Products: SRG-400
Serial Range: Starting with G4001166
Release Date: October 23, 2019

Baffle Board

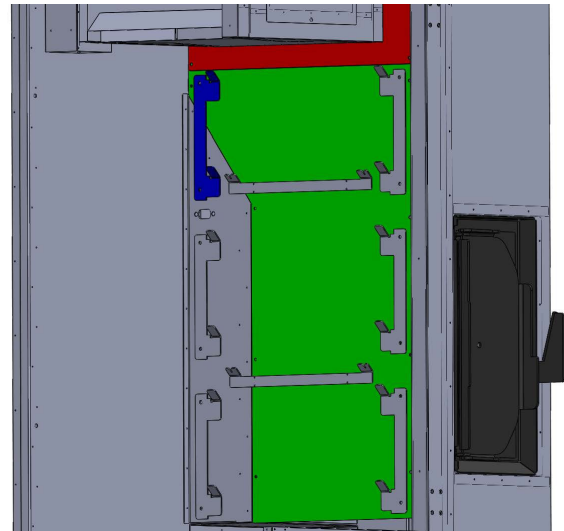
The baffle board in the SRG-400 has been divided into two pieces so that it can be more easily removed for cleaning. The top portion of the baffle board (red highlighted area) stays in the smoker, while the bottom portion (green highlighted area) is removed. **Before removing the bottom portion, the top, right, back wire rack slide hanger (blue highlighted area) must be removed from the interior liner of the smoker and the baffle board.**

At least quarterly, the baffle board should be removed, and the creosote scrapped off of the firebox side of the baffle board, along with the interior of the smoker around the firebox.
